Response to Highways England Deadline 7 Documents 8.80, 8.83, 8.84, 8.86 & 8.89:

8.80 Applicant's Comments on any Additional Information or Submissions Received by Deadline 6

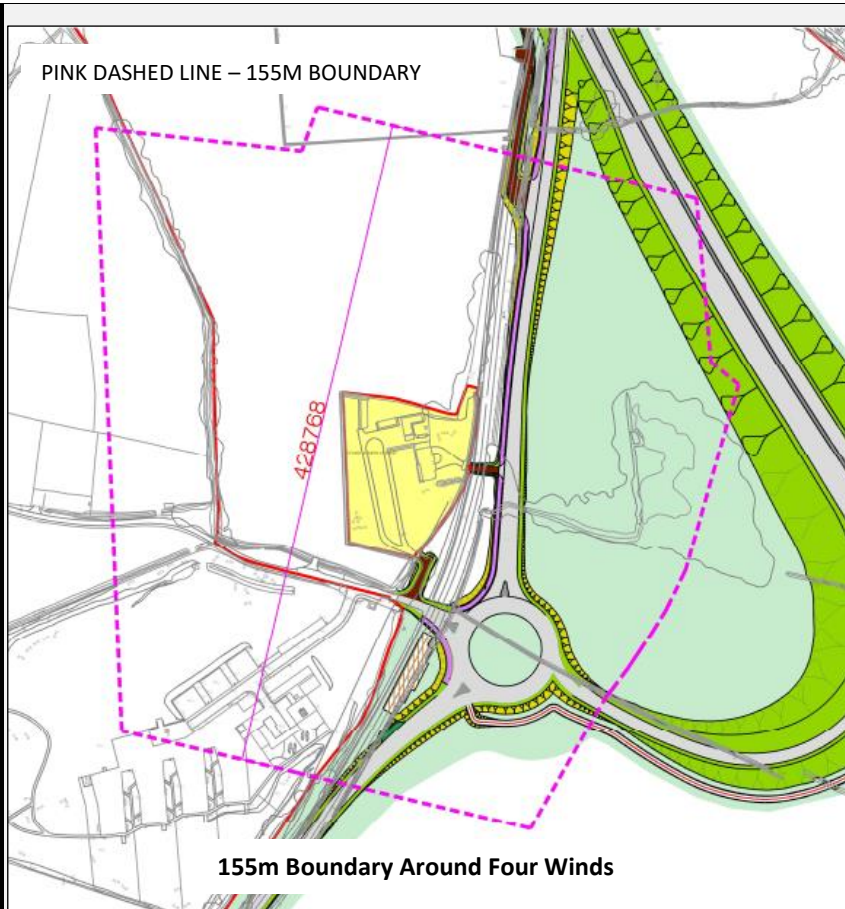
The drawing opposite illustrates the 155m boundary around my property.

The distance from the northern extreme of the 155m boundary to the southern extreme of the 155m boundary is almost 430m.

The works in this area will include, but are not limited to, the following:

- Removal of the existing Catherine de Barnes Lane and footpaths
- Construction of realigned Catherine de Barnes Lane and footpaths
- Construction of attenuation tank
- Construction of Barber’s Coppice Roundabout
- Construction of Merge Slip from Barber’s Coppice Roundabout to proposed Mainline link
- Construction of Mainline link
- Construction of reconfigured WGAA site

Plan of Current Taxi (& Airport Pickup) Parking Hotspots On or Adjacent to Catherine de Barnes Lane

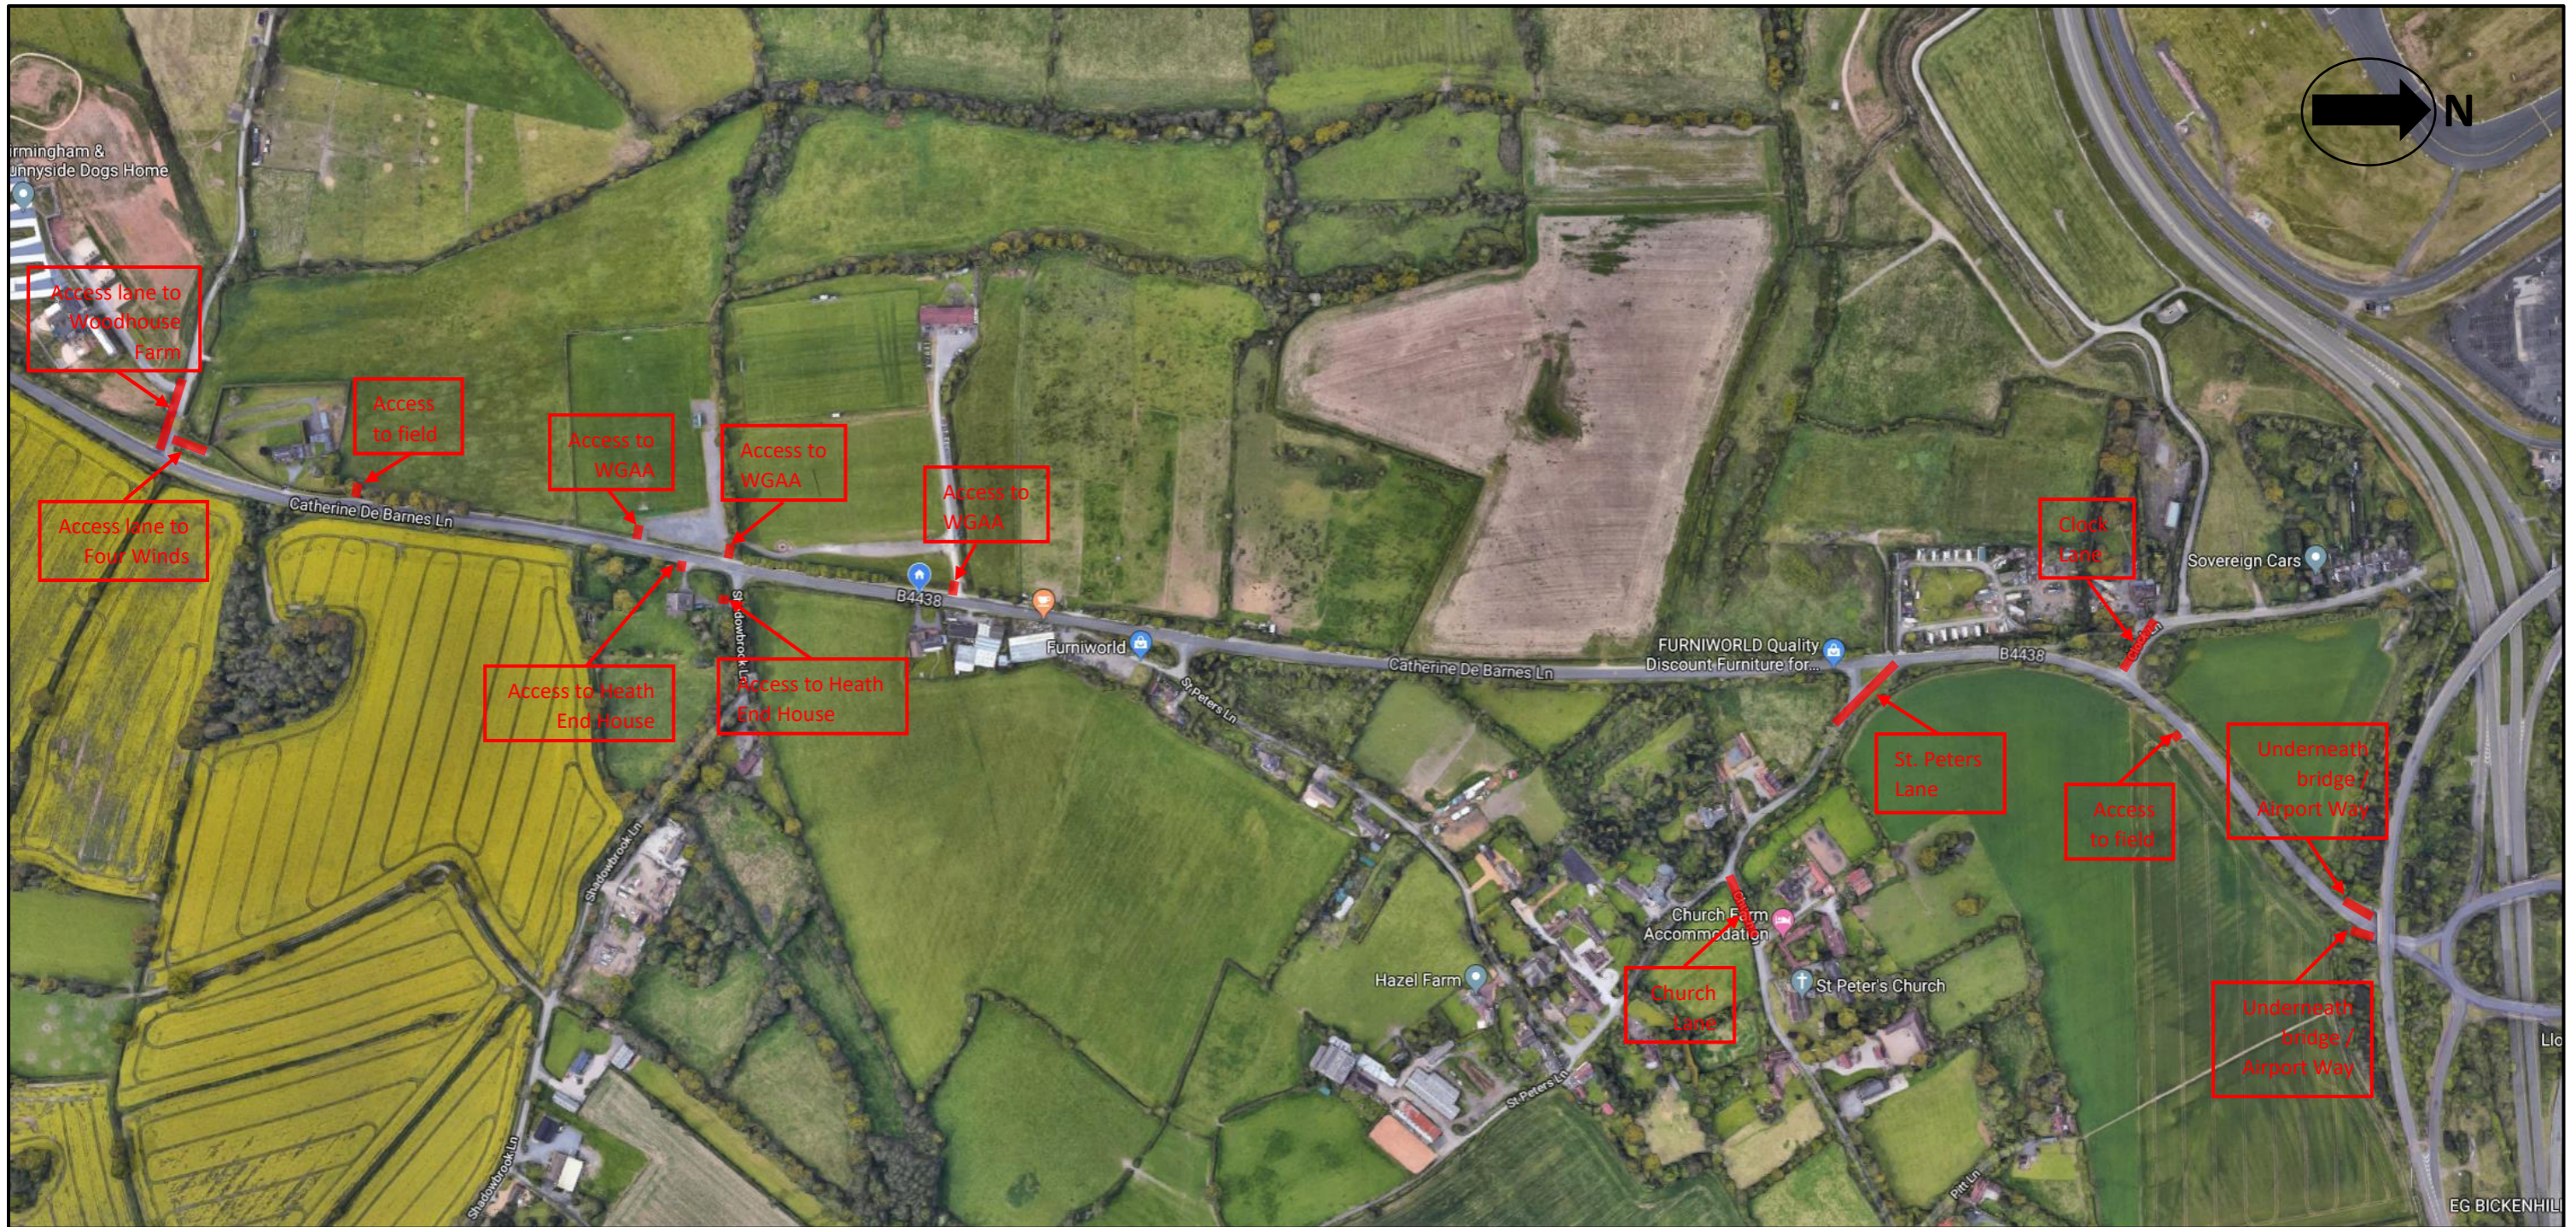
In my Deadline 6 submission *'Issue Specific Hearing on Living Conditions (1st October 2019)'* I explained that as the north bound carriageway of Catherine de Barnes Lane will be closed off, preventing access to the airport, train station, NEC and motorway network by vehicle, the current taxi parking hotspots at the north end of Catherine de Barnes Lane (see Appendix A) will migrate to the closest points of access via the new link road (see Appendix B). My property, and the area surrounding it, will be the closest point to access the airport, train station, NEC and motorway network by vehicle. As such it will become a hotspot for taxi parking and airport pickups.

The plans clearly illustrate the existing issue with taxis parking and how my property will be affected as a consequence of the M42 Jct 6A works.
